UNITED STATES PATENT AND TRADEMARK OFFICE

APPLICATION NO.	FILING DATE	FIRST NAMED INVENTOR	ATTORNEY DOCKET NO.	CONFIRMATION NO.
10/696,214	10/28/2003	Kiri B. Amarakoon	D/A2518	7332
25453	7590	06/06/2005	EXAMINER CHEN, SOPHIA S	
PATENT DOCUMENTATION CENTER XEROX CORPORATION 100 CLINTON AVE., SOUTH, XEROX SQUARE, 20TH FLOOR ROCHESTER, NY 14644			ART UNIT 2852	PAPER NUMBER

Office Action Summary

DETAILED ACTION

FIG. 1

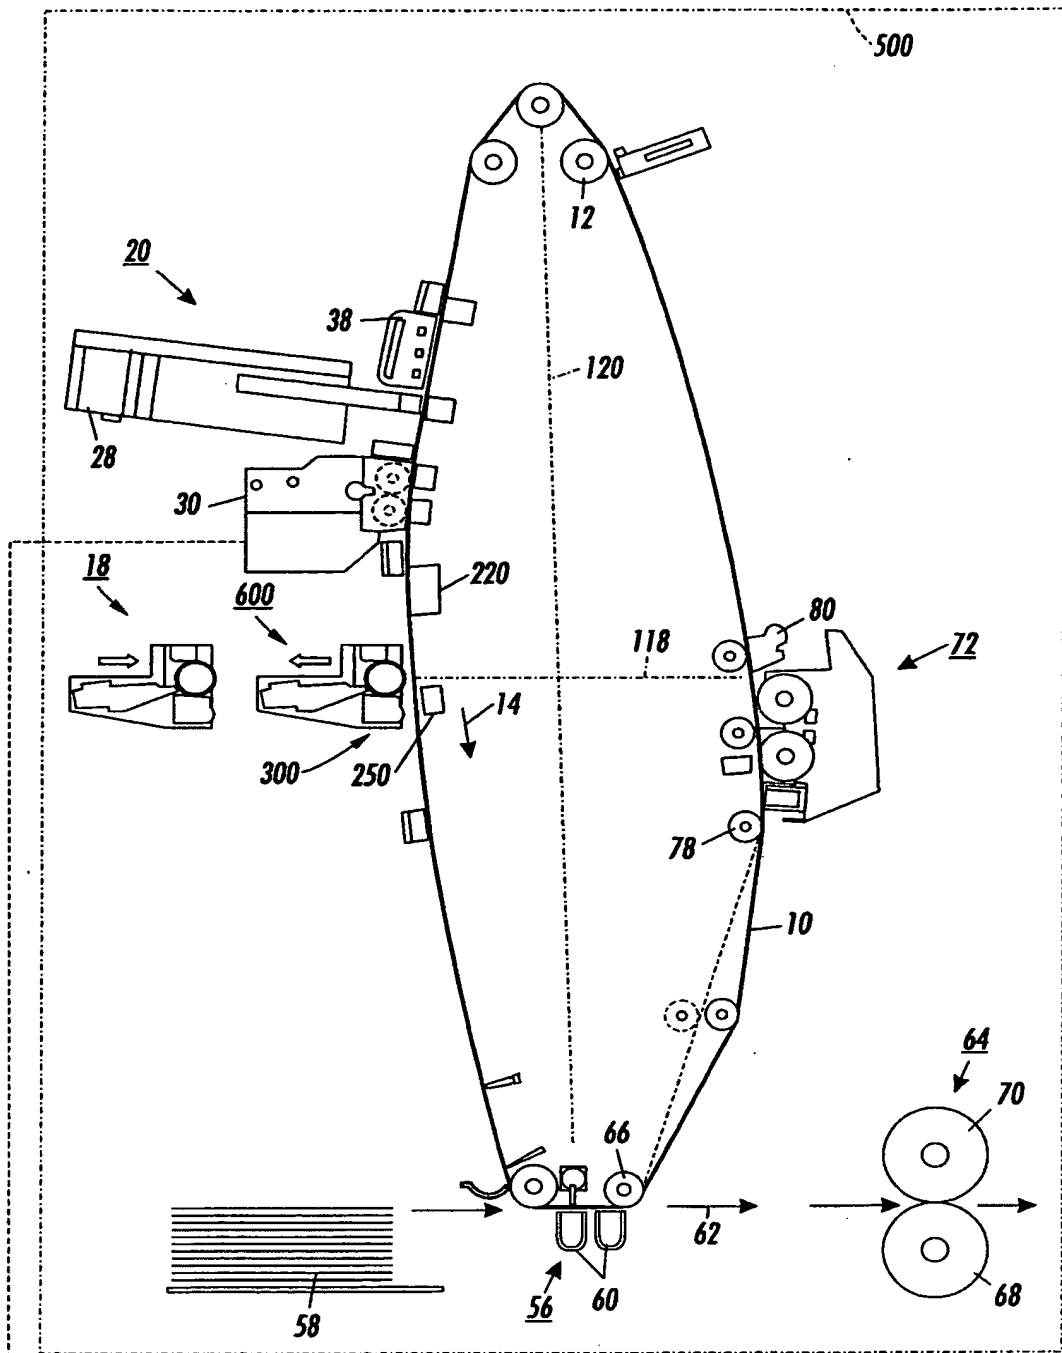
1. The drawings were received on 5/5/05. These drawings are disapproved. See the explanation listed below.
2. The drawings are objected (secondly) to as failing to comply with 37 CFR 1.84(p)(5) because they do not include the following reference sign(s) mentioned in the description: **22, 24** (page 5, line 1), and **26** (page 5, line 13). Corrected drawing sheets in compliance with 37 CFR 1.121(d) are required in reply to the Office action to avoid abandonment of the application. Any amended replacement drawing sheet should include all of the figures appearing on the immediate prior version of the sheet, even if only one figure is being amended. Each drawing sheet submitted after the filing date of an application must be labeled in the top margin as either "Replacement Sheet" or "New Sheet" pursuant to 37 CFR 1.121(d). If the changes are not accepted by the examiner, the applicant will be notified and informed of any required corrective action in the next Office action. The objection to the drawings will not be held in abeyance.

3. The drawings are objected (secondly) to as failing to comply with 37 CFR 1.84(p)(5) because they include the following reference character(s) not mentioned in the description: **38** (Figure 1). Corrected drawing sheets in compliance with 37 CFR 1.121(d), or amendment to the specification to add the reference character(s) in the description in compliance with 37 CFR 1.121(b) are required in reply to the Office action to avoid abandonment of the application. Any amended replacement drawing sheet should include all of the figures appearing on the immediate prior version of the sheet,

4. The drawings are objected (secondly) to as failing to comply with 37 CFR 1.84(p)(4) because reference character "500" has been used to designate both "an image forming apparatus" (Figure 1) and "a module" (page 5, paragraph [0015], line 1, etc.). Corrected drawing sheets in compliance with 37 CFR 1.121(d) are required in reply to the Office action to avoid abandonment of the application. Any amended replacement drawing sheet should include all of the figures appearing on the immediate prior version of the sheet, even if only one figure is being amended. Each drawing sheet submitted after the filing date of an application must be labeled in the top margin as either "Replacement Sheet" or "New Sheet" pursuant to 37 CFR 1.121(d). If the changes are not accepted by the examiner, the applicant will be notified and informed of any required corrective action in the next Office action. The objection to the drawings will not be held in abeyance.

disapproved (K) 5/31/05

FIG. 3

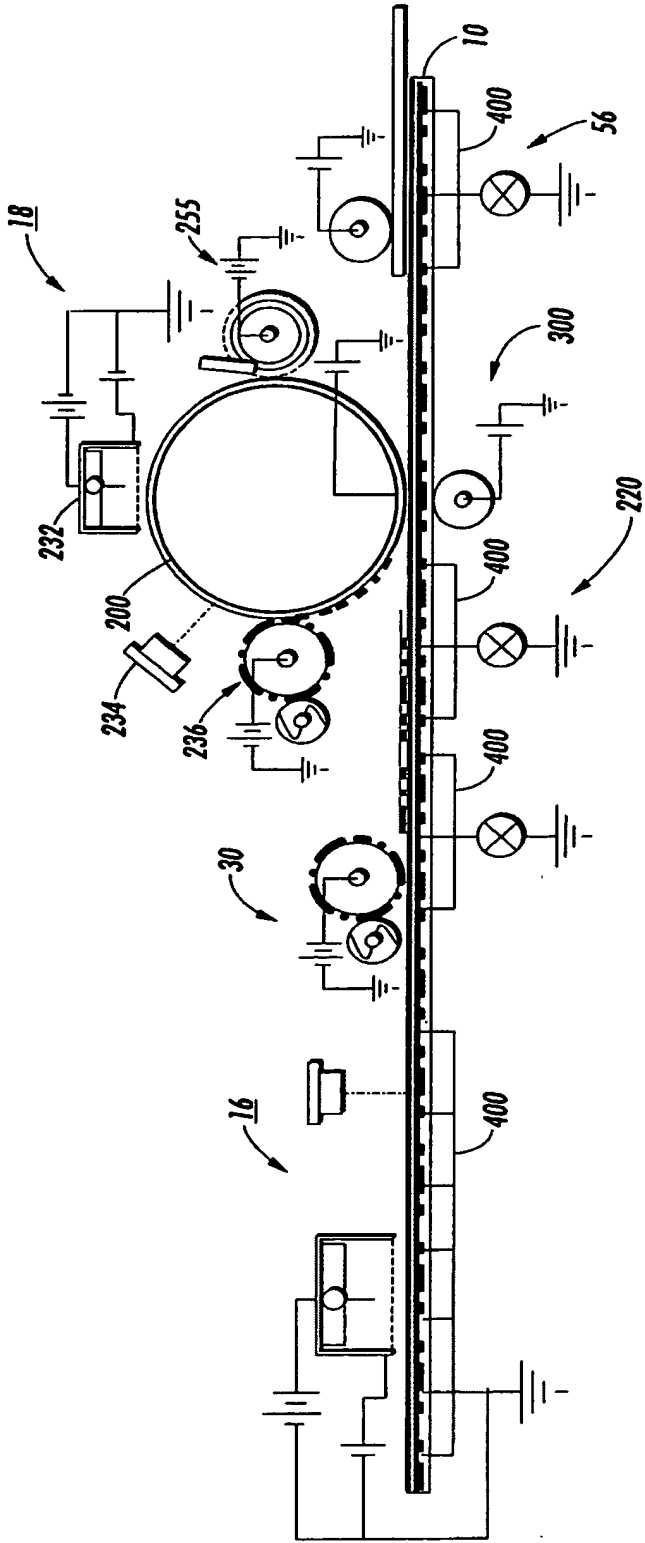
disapproved (82) 5/11/05
